File No.: 04-1000-20-2020-387

Re: **Request for Access to Records under the Freedom of Information and Protection of Privacy Act (the "Act")**

CITY OF VANCOUVER  
ENGINEERING SERVICES

**RESIDENTIAL DEVELOPMENT**  
KING EDWARD AVENUE, WEST OF CAMBIE STREET, VANCOUVER, B.C.  
SHORING - SITE PLAN

**SITE PLAN**  
SCALE = 1:300

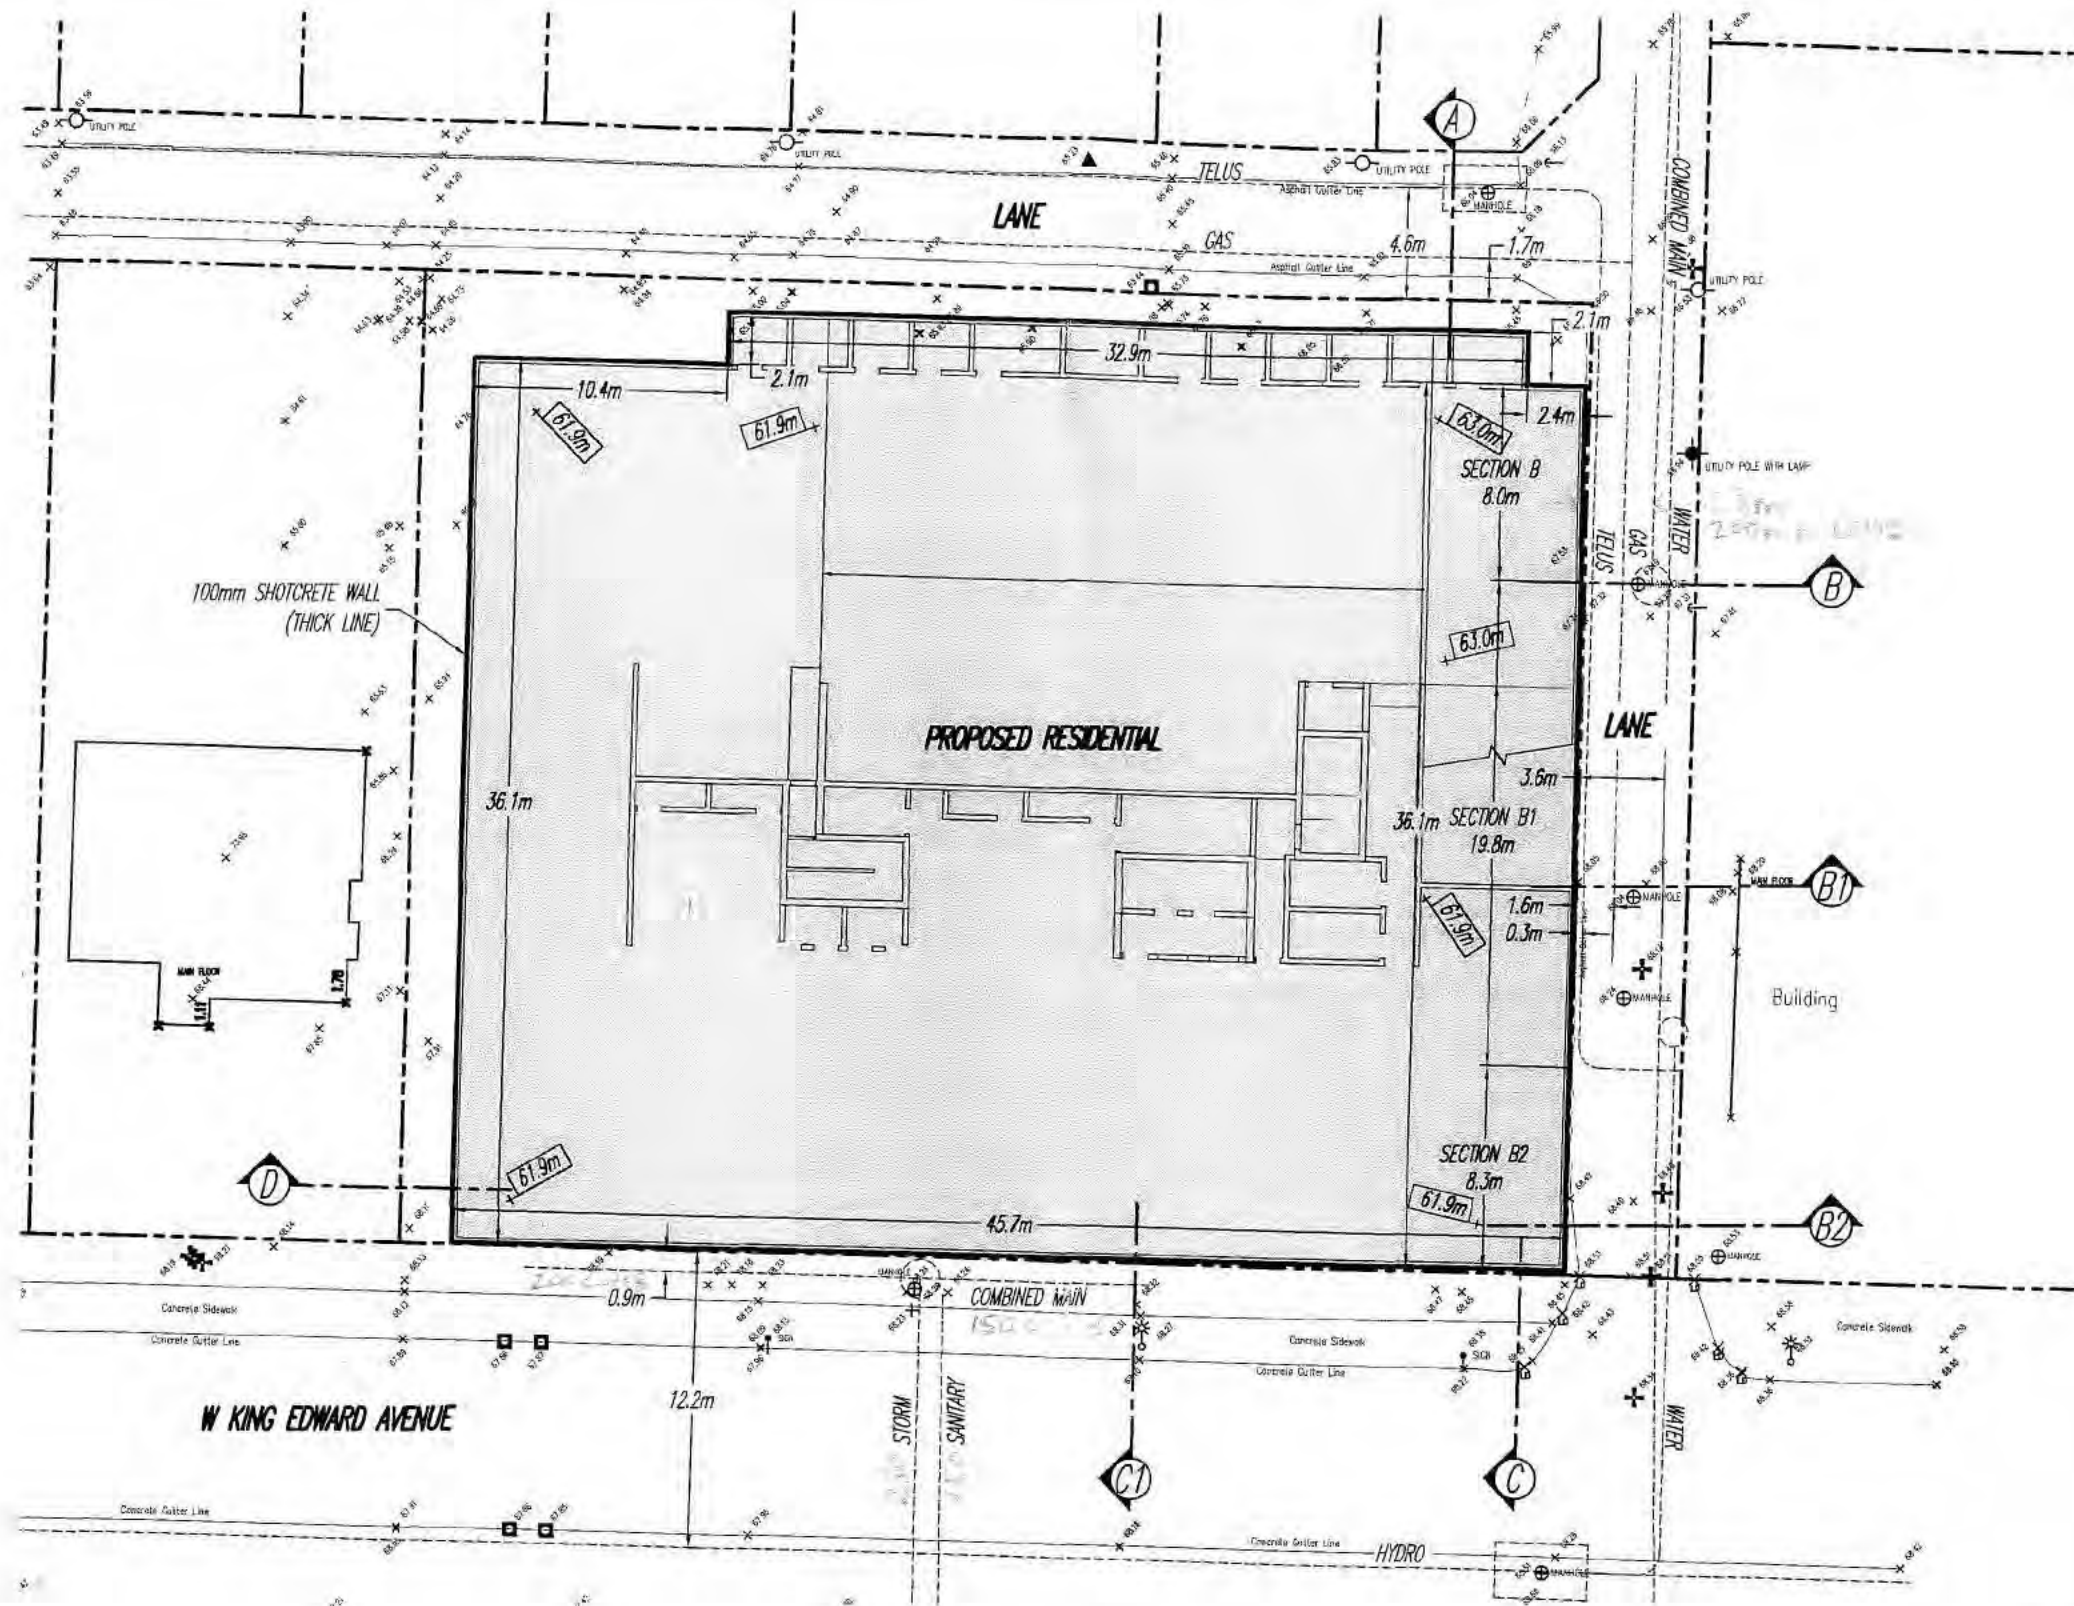
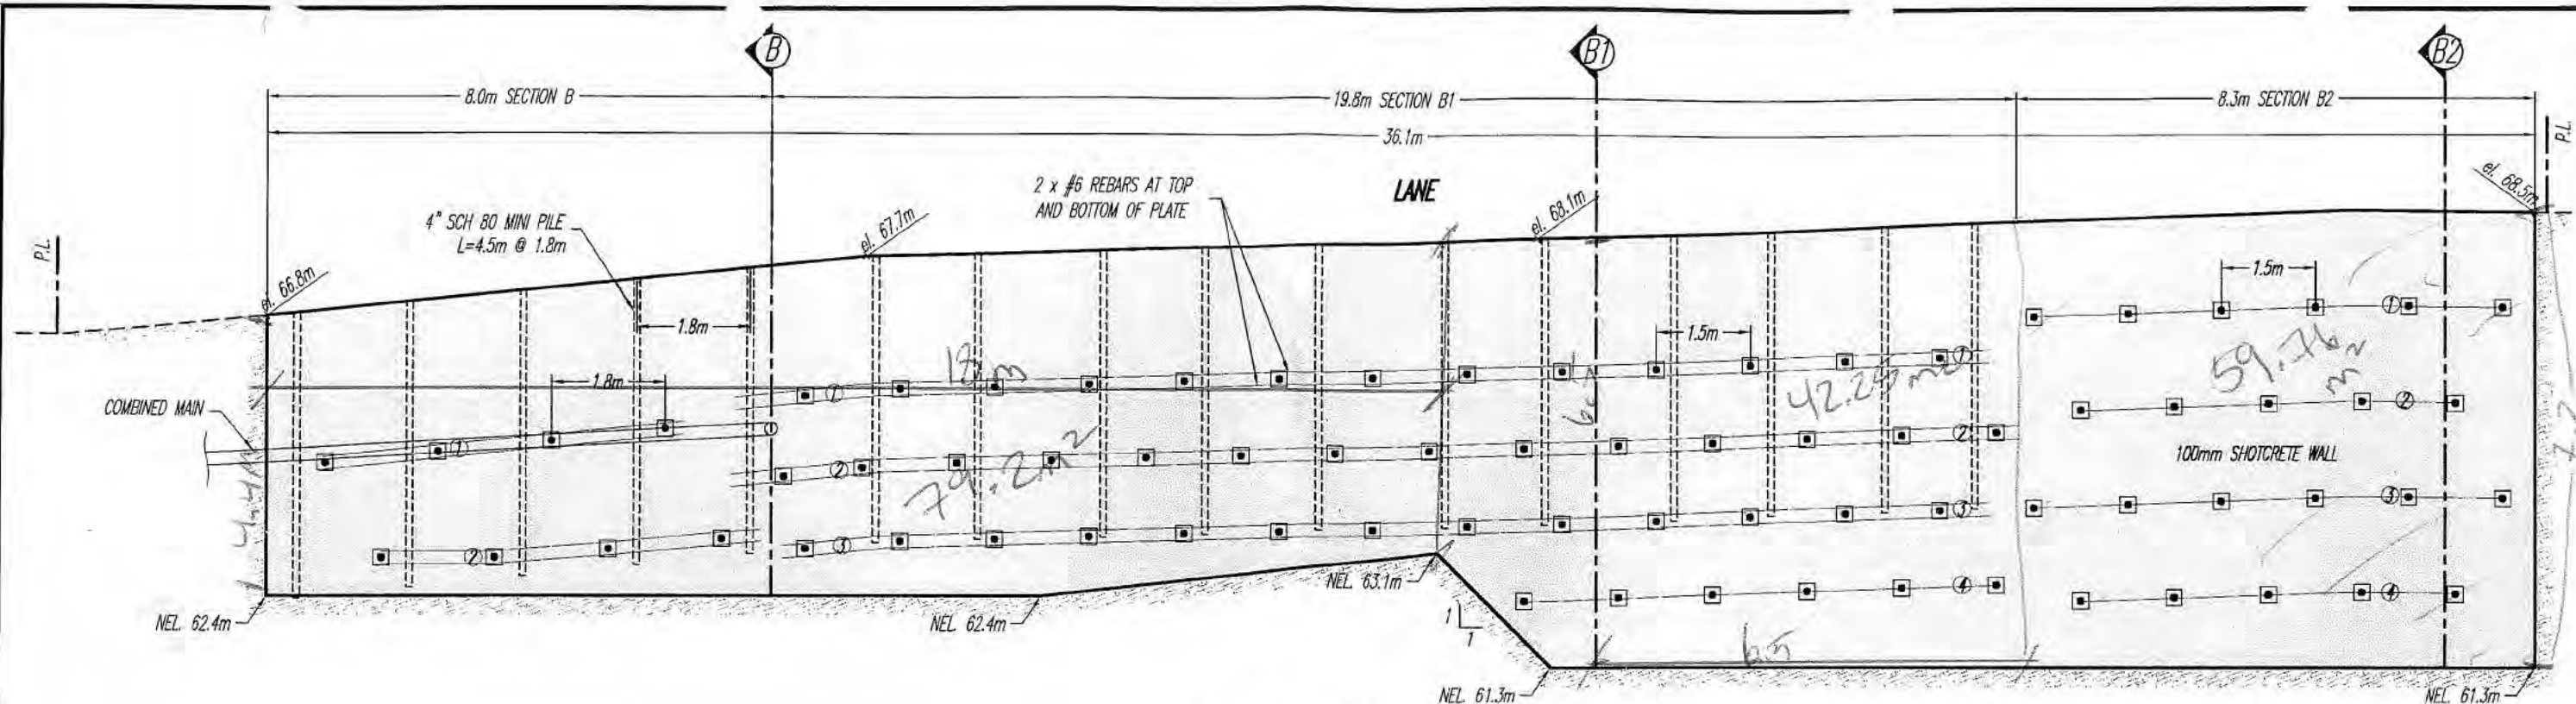
REVISE DRAWING. MAINTAIN 0.9m SEPARATION FROM SEWER MANHOLE.

SHOW SEWER MANHOLE IN X-SECTION AND 250STM/150SAN ~~RM~~ PIPES THAT ARE CROSSING W KING EDWARD AV.

SHOW SEWER PIPE DIAMETERS.

TV 16.1m - 200C ON W KING EDWARD // TV 23.9m - 250STM ON W KING EDWARD //

TV 24.7m - 150SAN ON W KING EDWARD. TV INSPECTION FEE \$2,000 + GST

FILE NO.: **12589**  
DWG. NO.: **G-S4B**

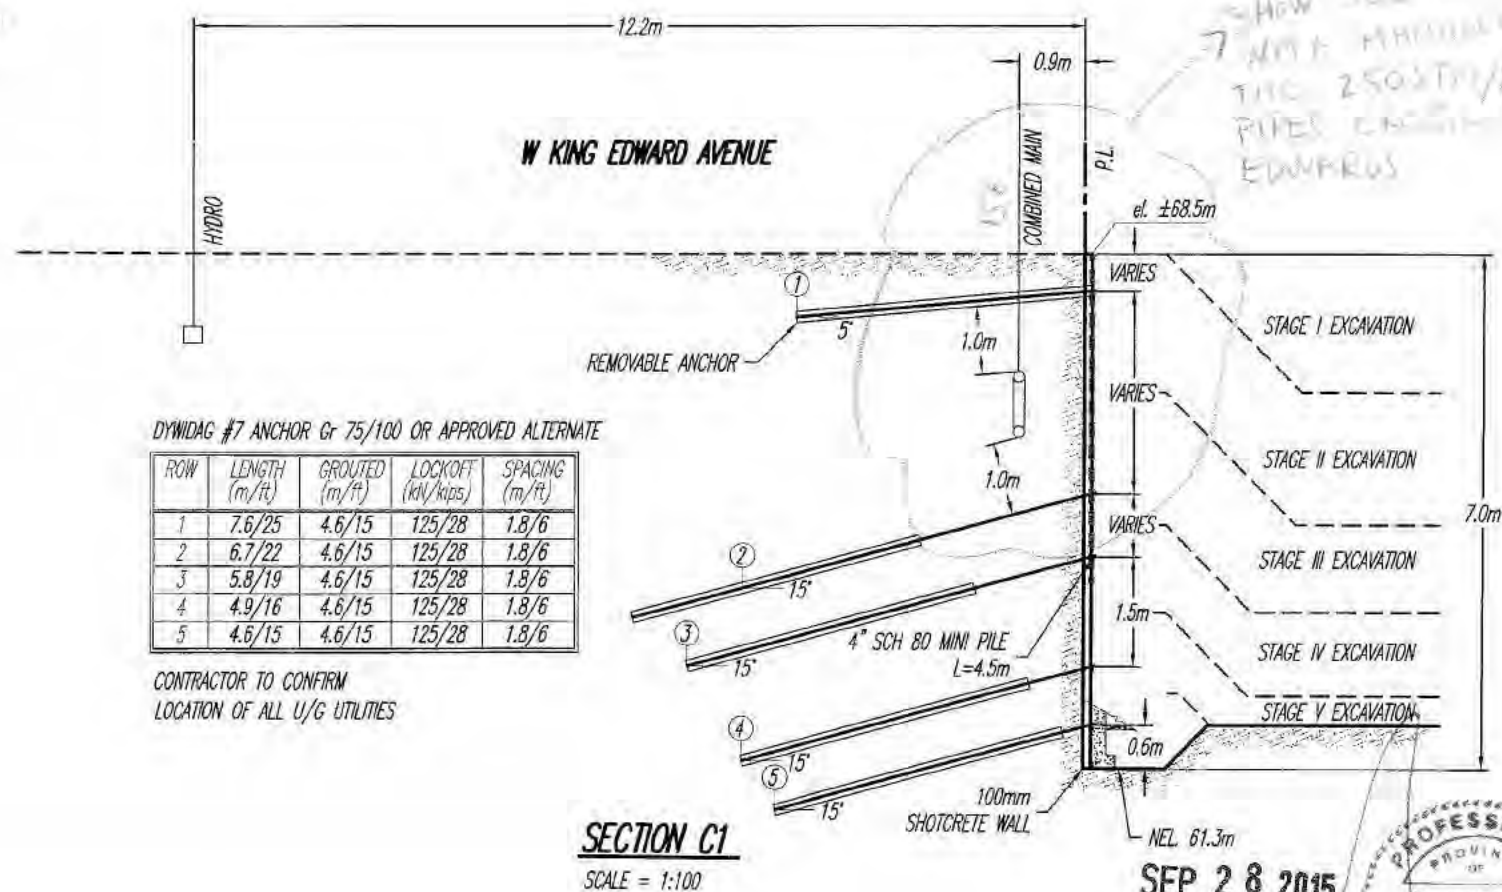
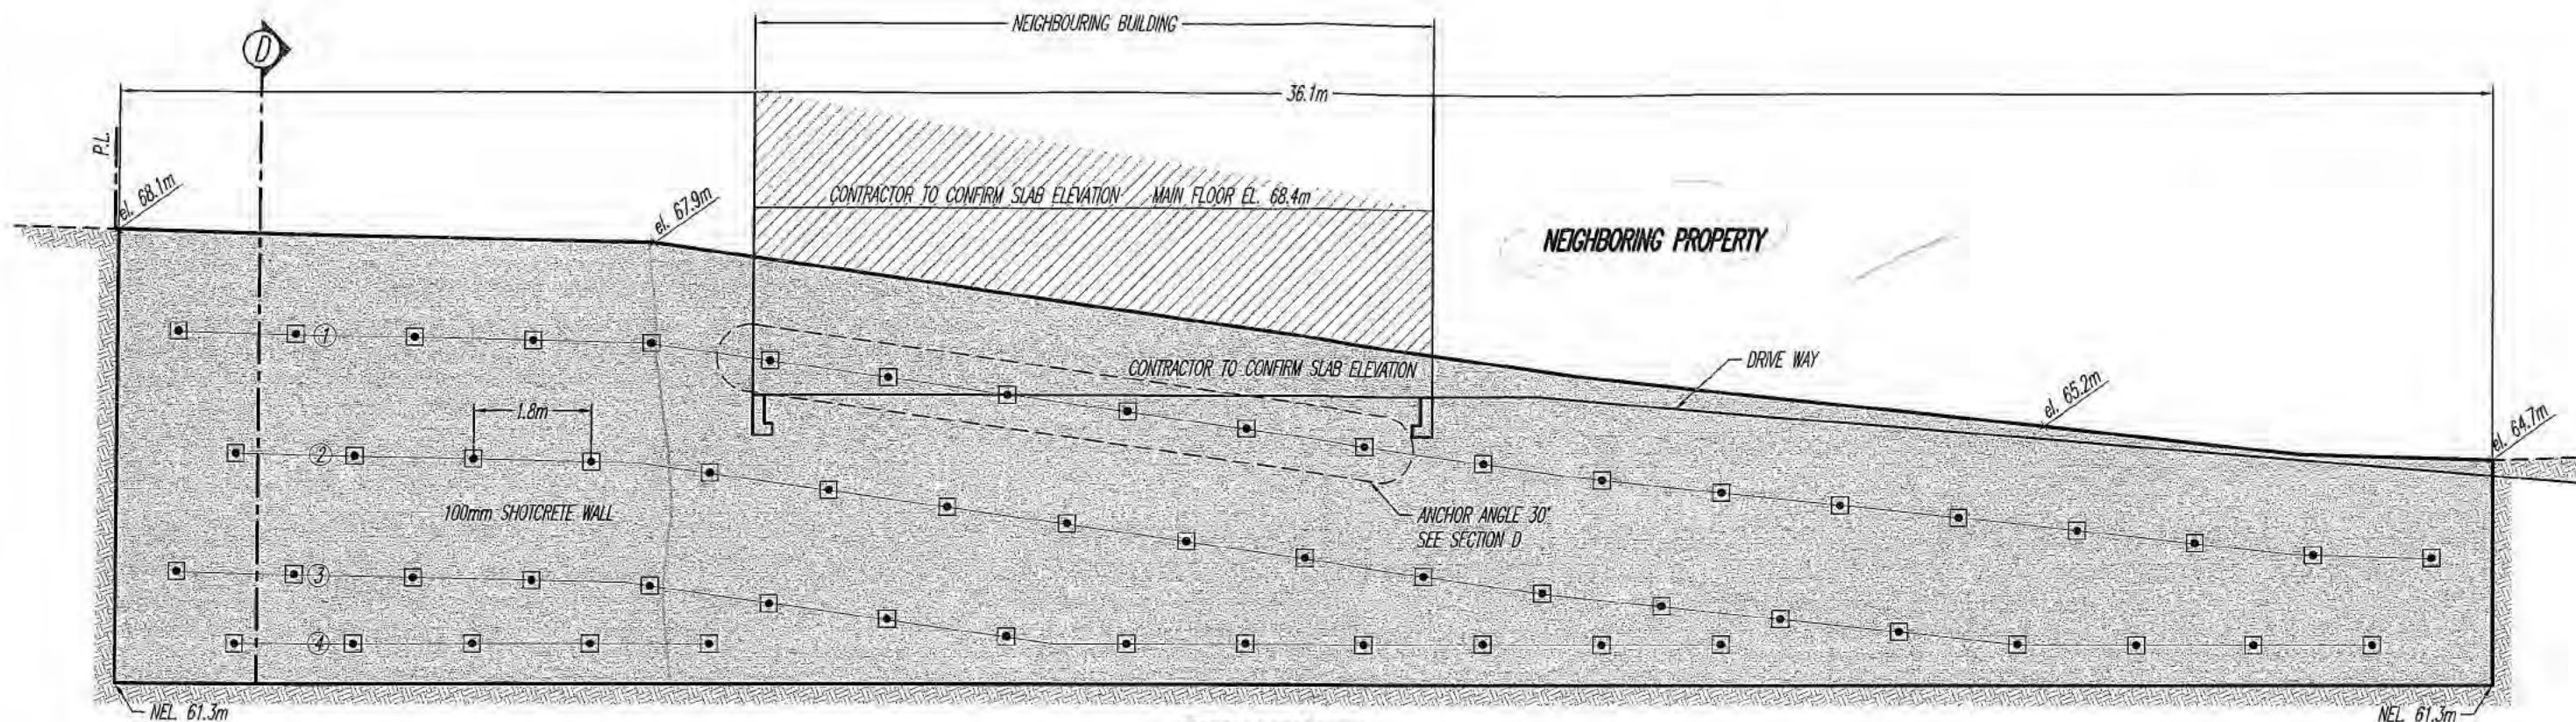
SHOW SECTION  
WITH MINIMUM  
TWO 250MM/150MM  
PIPER EXISTING IN WITH  
EDWARDS
